RBG-47983

Subject: Application to Revise Technical Specification 3.3.5.2, "RPV Water Inventory Control Instrumentation" to Adopt TSTF-425, "Relocate Surveillance Frequencies to Licensee Control - RITSTF Initiative 5b."

River Bend Station, Unit 1  
NRC Docket No. 50-458  
Renewed Facility Operating License No. NPF-47

SR 3.3.5.2.2

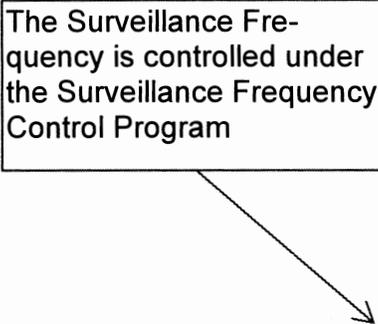
Any setpoint adjustment shall be consistent with the assumptions of the current plant specific setpoint methodology.

The Surveillance Frequency is controlled under the Surveillance Frequency Control Program
